# ODOT-DPM01

## ODOT Modbus to profibus converter with Siemens PLC (S7-300)( simatic manager)

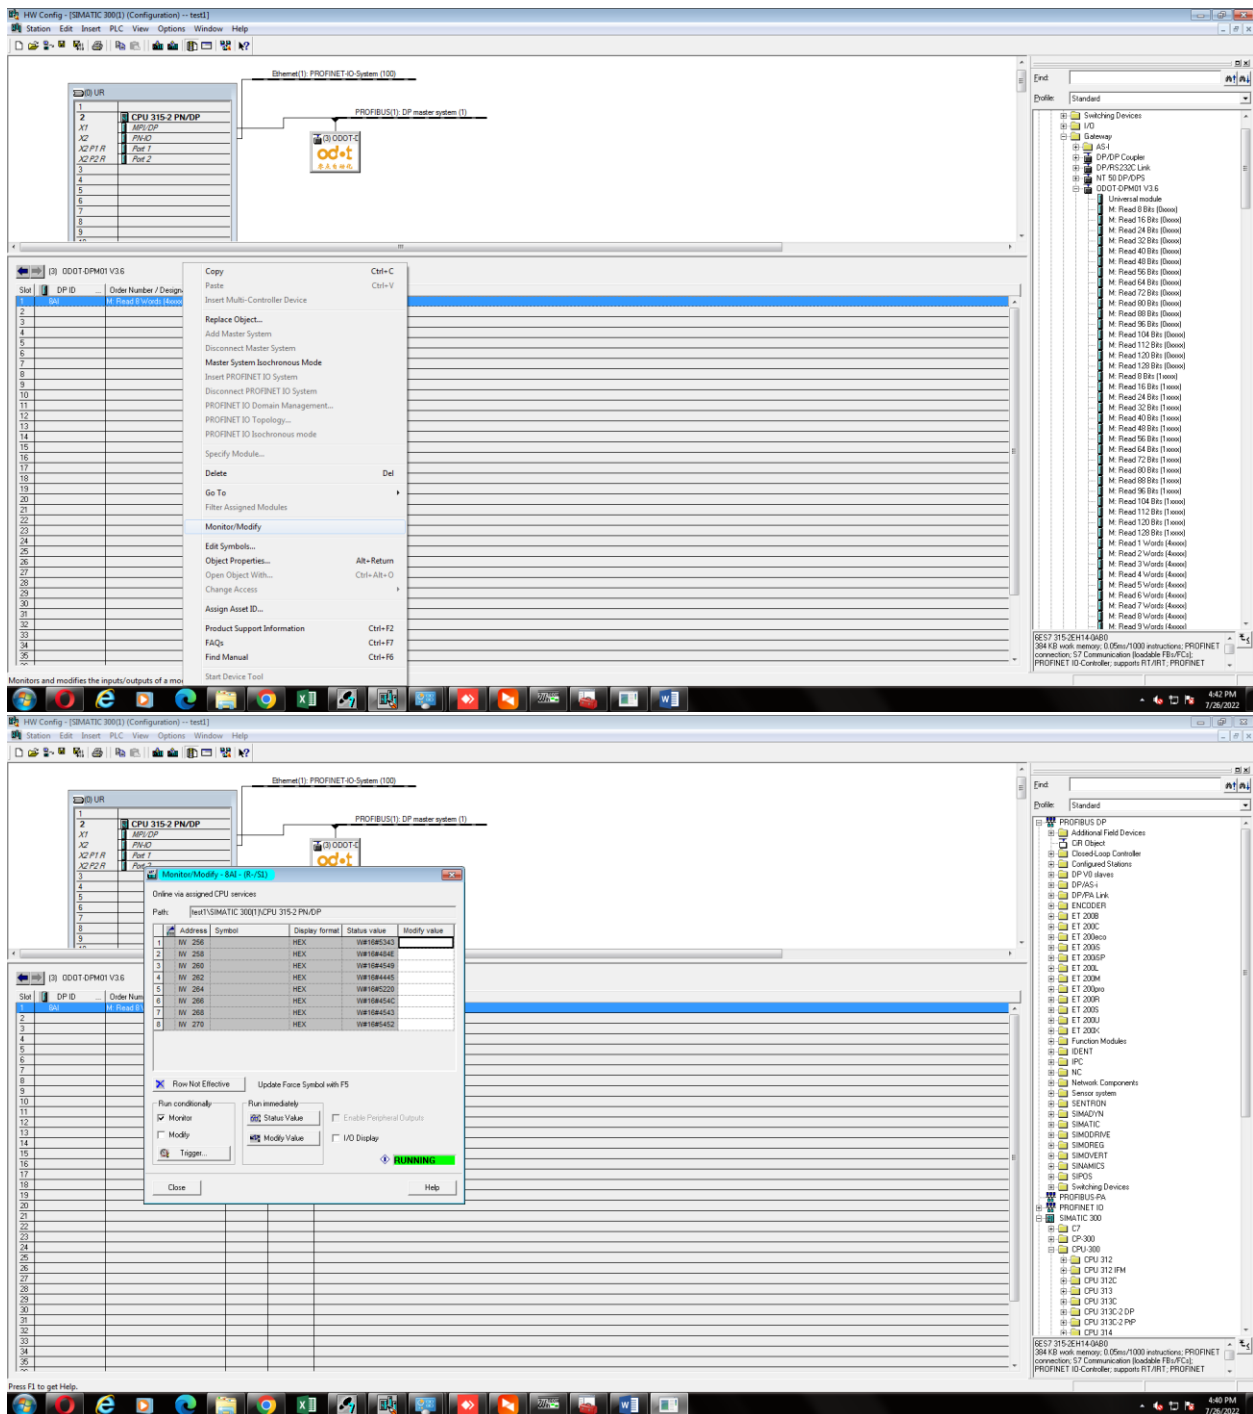
There are two problems with your setup today. The first is that the command start address should start at 0 instead of 40001.

the 4 of 40001 which refers to area 4.

The second is that the process mapping area of S7-300 is 128 words by default, and the allocation gateway often exceeds this amount, so it is necessary to expand the process mapping area to 512 or 1024 in the CPU properties.

[4:13 PM, 7/26/2022] BluBoxx Tech Support: so why the valu not show in programming software

[12:38 PM, 7/27/2022] BluBoxx Tech Support: we have a temperature sensor these values start from 30001 it is an input registry so which register should we use to get the proper value,

[2:28 PM, 7/27/2022] BluBoxx Tech Support: if i want map the input register ( start form 30001) what i need to configure in parameter to get values

- \* The process mapping area of S7-300 is 128 words by default, and the allocation gateway often exceeds this amount, so it is necessary to expand the process mapping area to 512 or 1024 in the CPU properties.

[4:14 PM, 7/26/2022] Odot Automation Raphel: Ok pls wait we need to set the process mapping data

[4:22 PM, 7/26/2022] Odot Automation Raphel: We have completed the mapping data configuration.

[12:25 PM, 7/28/2022] Odot Automation Raphael: Good afternoon. For 30001, it means 1st number in area 3, so you need use 0 as the start address.

[12:26 PM, 7/28/2022] Odot Automation Raphael: It needs to read area 3 with the start address of 0

[12:26 PM, 7/28/2022] Odot Automation Raphael: And please select 4. Input Register
